Certificate of Appropriateness

BAR # 24-10-01

1301 Wertland Street, Tax Map Parcel 040303000

Project: Apartment building. Modifications to approved CoA (January 2023).

PROPOSED EAST ELEVATION

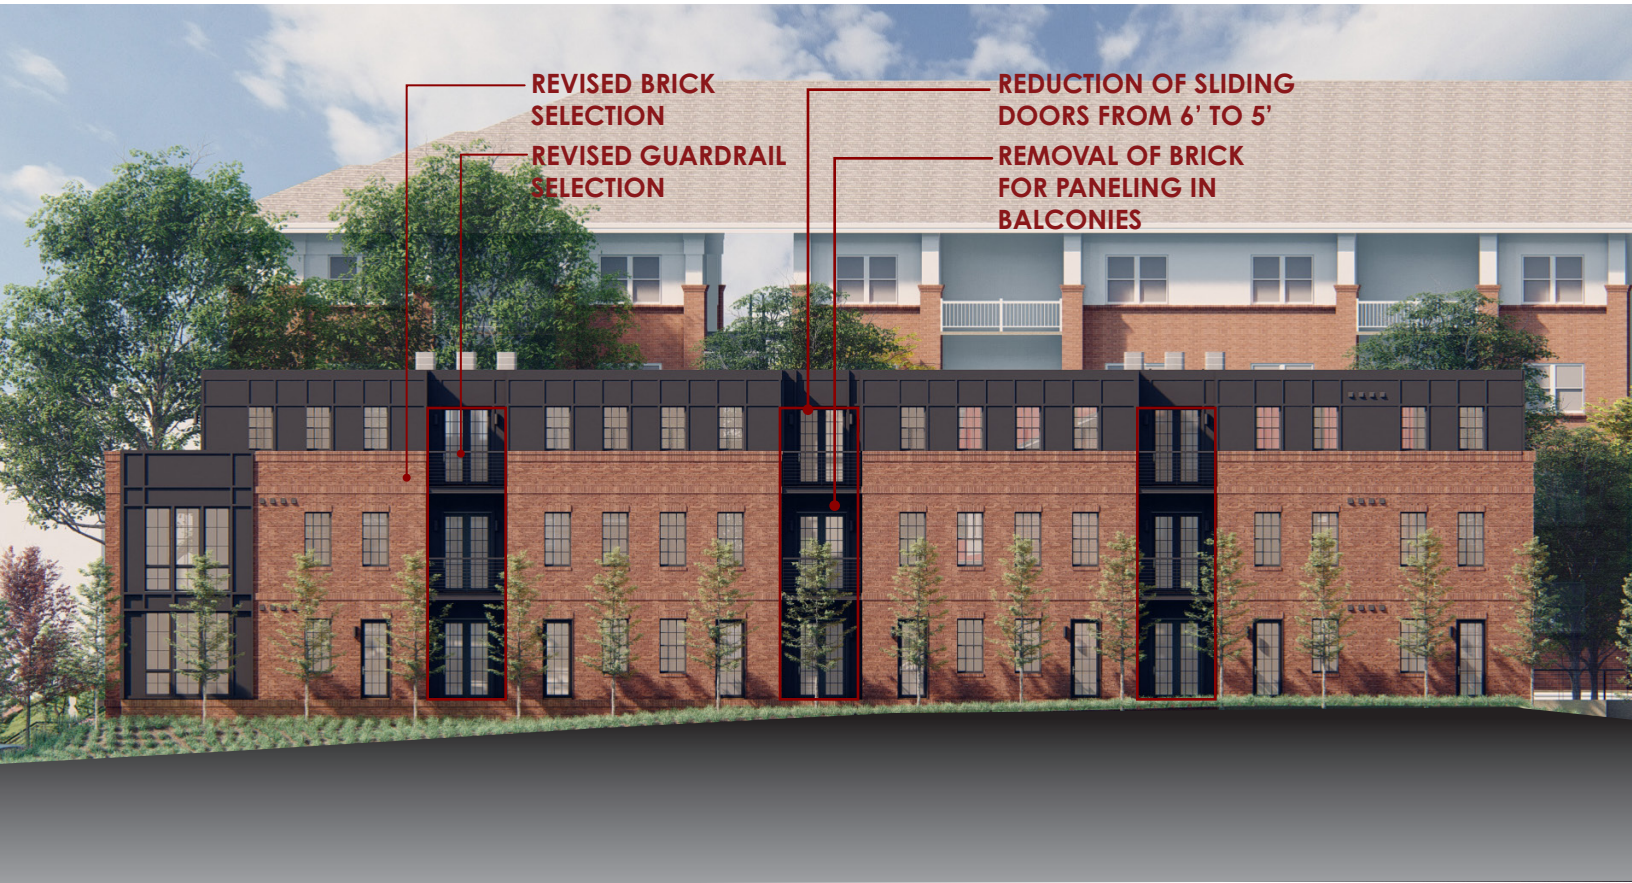
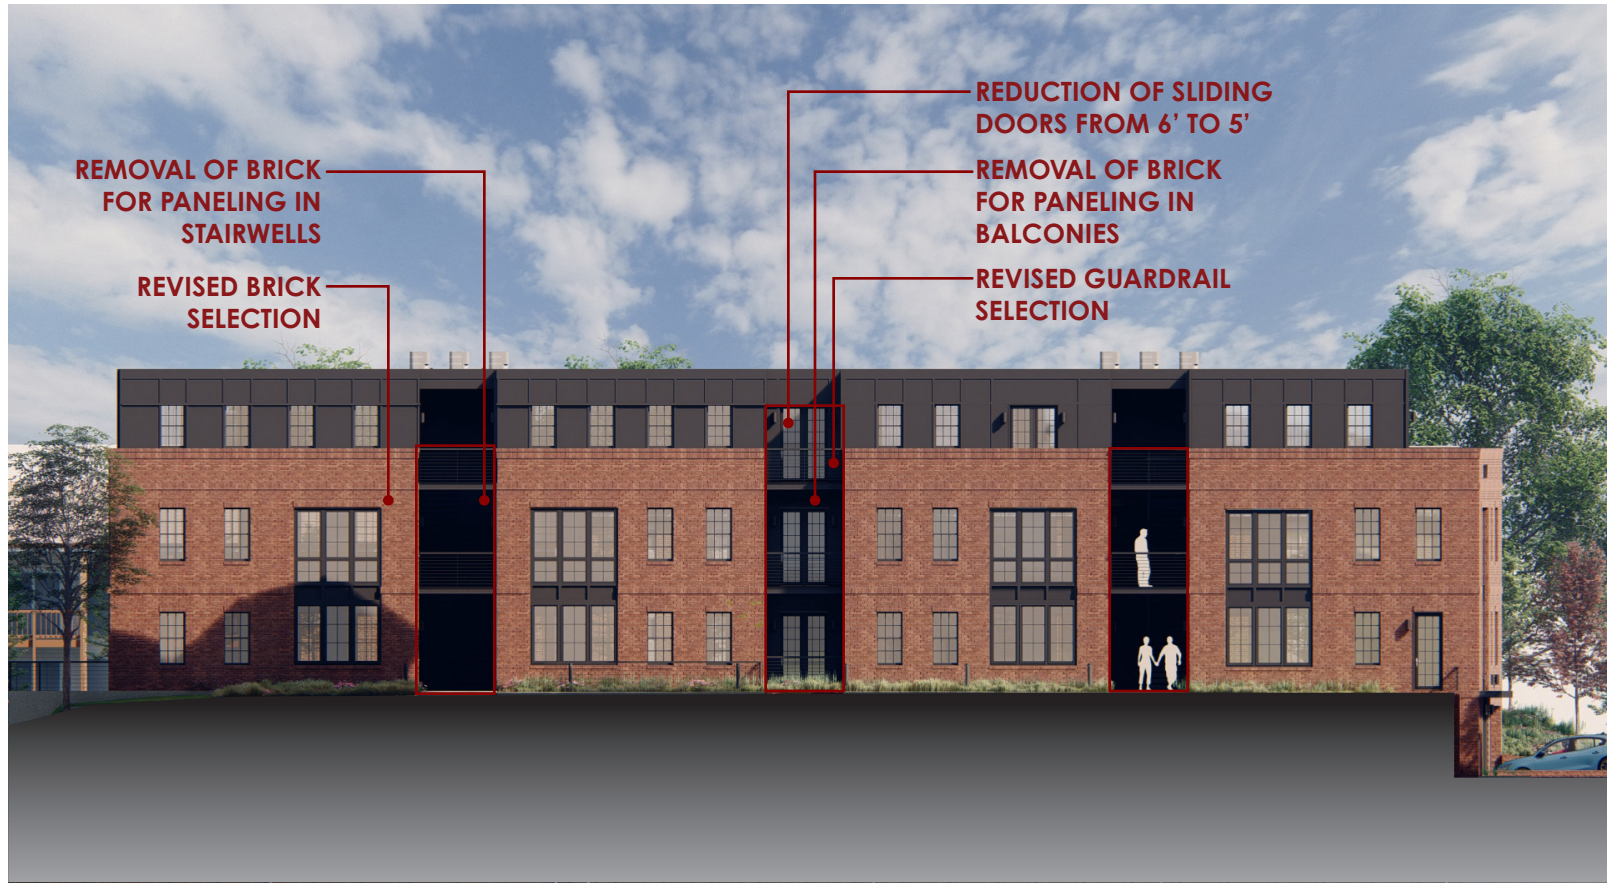
- Alternate brick and mortar selections.
- Alternate balcony railings: Trex Signature Aluminum Railing. Color: “Charcoal Black”.
- East and west (side) elevations:
  - Replace brick at 1<sup>st</sup> and 2<sup>nd</sup> floor balcony and stairwell walls with painted, cement-board panels.
  - Reduce width of sliding doors from 6-feet to 5-feet.
- North (rear) elevation:
  - Replace twin windows and doors with single units.
  - Building wall: Replace brick with painted, cement-board panels.
  - Alternate railing: Trex Signature Aluminum Railing. Color: “Charcoal Black”.
  - Retaining wall: Replace brick with finished concrete.

PREVIOUS BRICK:  
OLD CAROLINA BRICK COMPANY  
HANDMADE BRICK IN "WINDSOR"

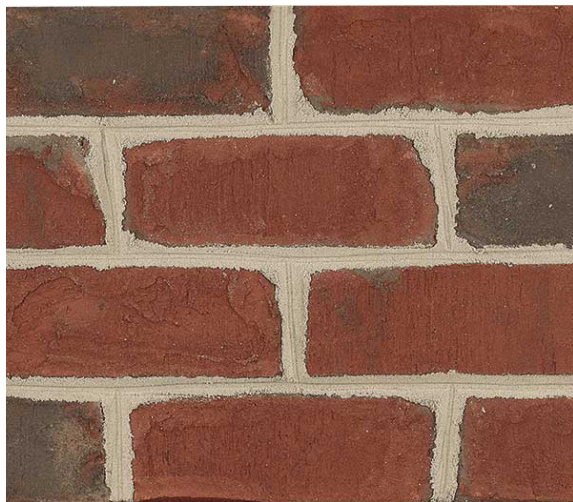
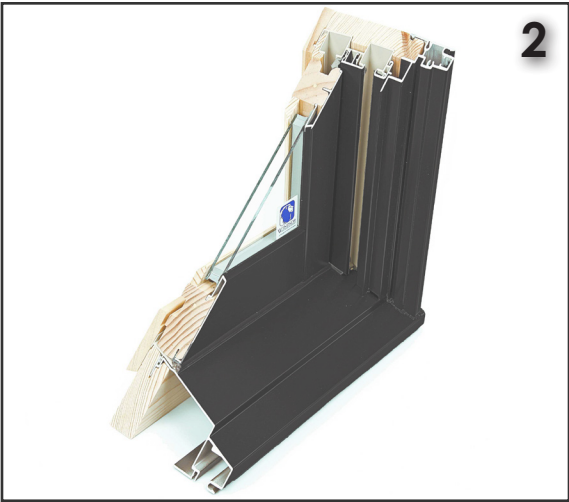
POTENTIAL ALTERNATIVES:

GLEN-GERY BRICK IN  
"DANISH 1776"

WATSON TOWN BRICK IN  
"PALISADES PARK"

PINE HALL BRICK IN  
"OLD YORKTOWN"

**TREX SIGNATURE ALUMINUM RAILING**

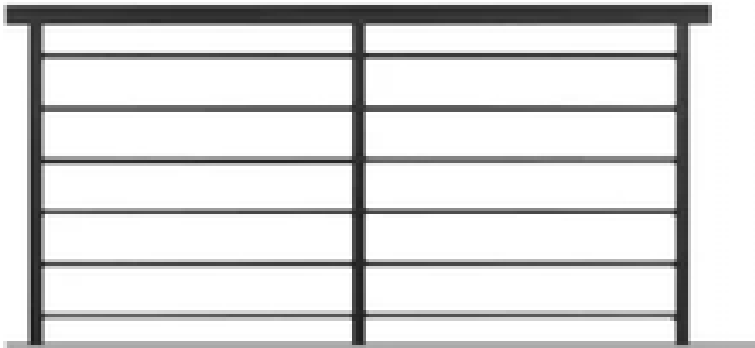
TREX SIGNATURE ALUMINUM RAILING  
IN CHARCOAL BLACK

SQUARE BALUSTER WITH ROD RAIL INFILL, 42" HEIGHT

PREFERRED ALTERNATIVE: PINEHALL BRICK  
OLD YORK TOWN O/S TUMBLED  
(WEST FACADE)

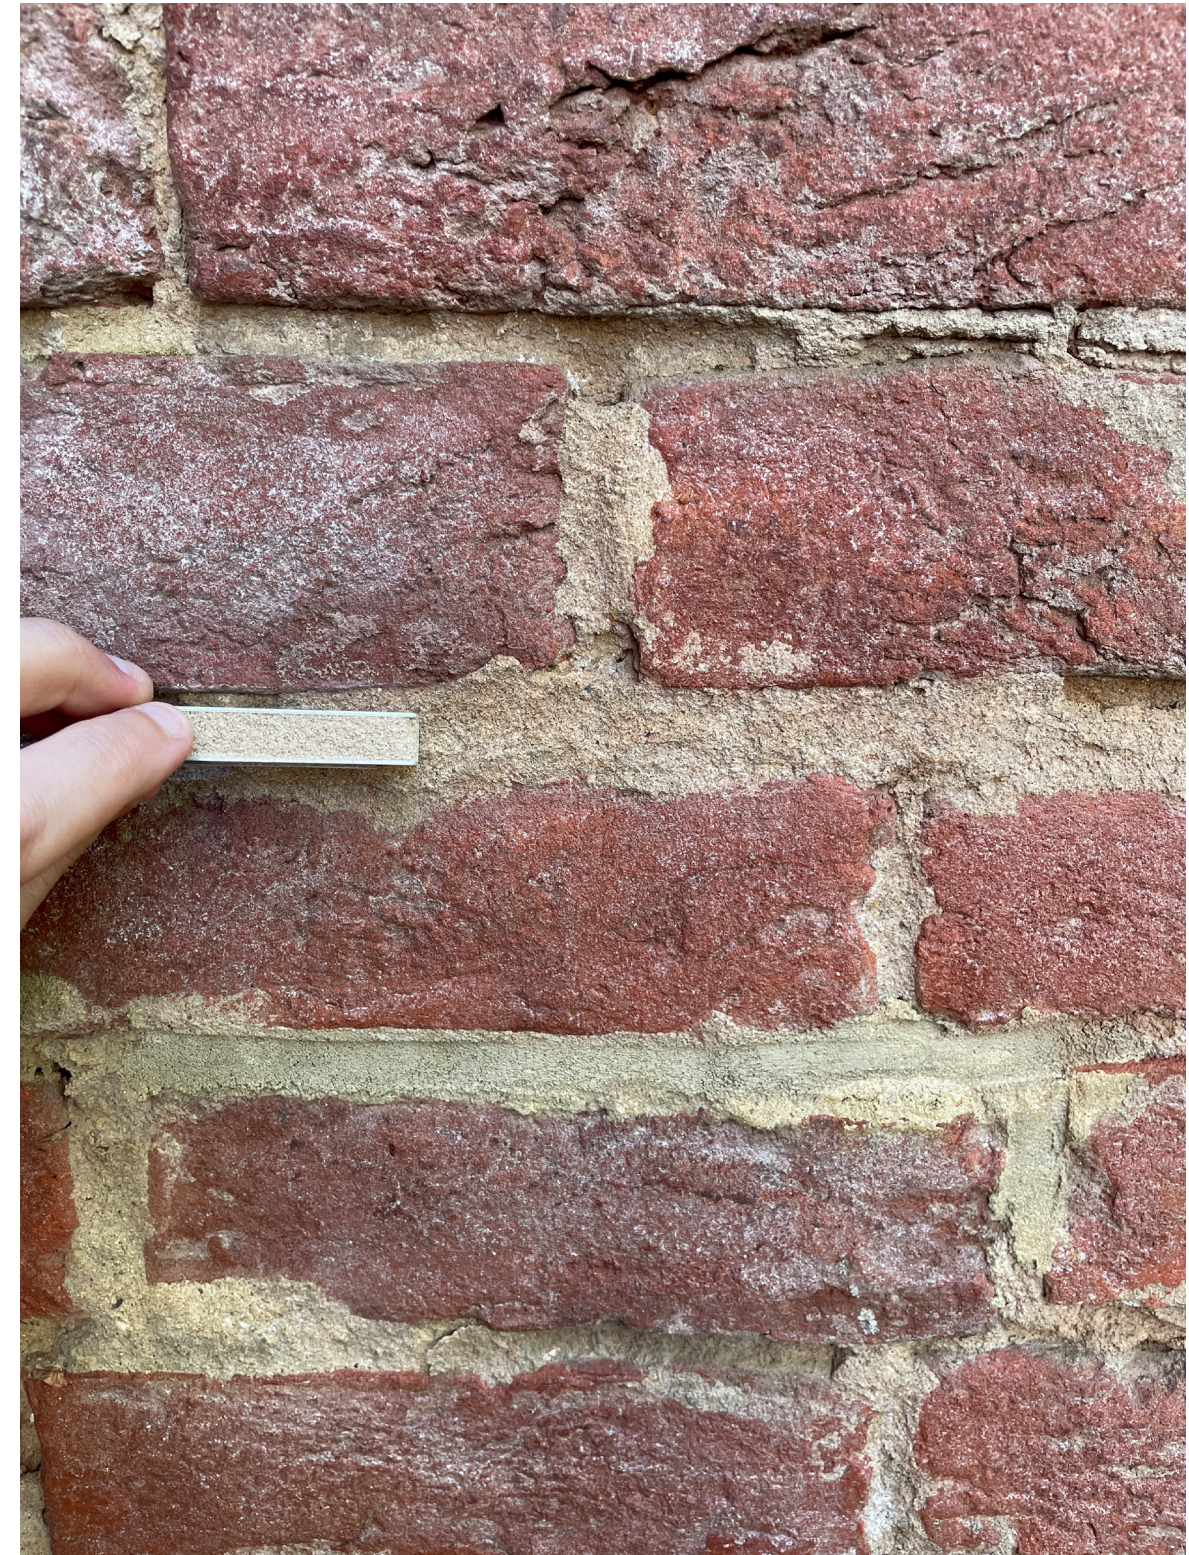
PREVIOUSLY APPROVED SELECTION

PREFERRED ALTERNATIVE IN FULL SUN  
(SOUTH FACADE / MID-AFTERNOON)

PREFERRED MORTAR: WORKRITE "MORNING MIST"  
WR2247A
